Access Compliance Report

Public Rights-of-Way

(Curb Ramps)

Intersection ID: 27041	Main Street: ENDAVEN_LN	Cross Street: ORCHID_HILL_LN	Location: W
ADA ID: D2A6142DE65F	Ramp Type: Para	Initial Pass/Fail: Fail	Overall Compliance: No
Severity Score: 21.25			
Codes/Mitigation Info/Possible Solution		Field Measurements/Component Compliance

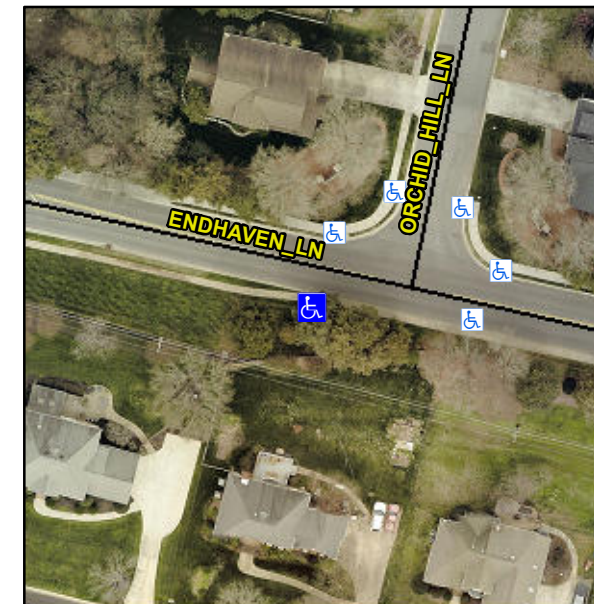
RT RP < 5%

PROW/ADA:

R304.5.1, R304.3.2

Possible Solutions:

Remove & Replace Entire Ramp.
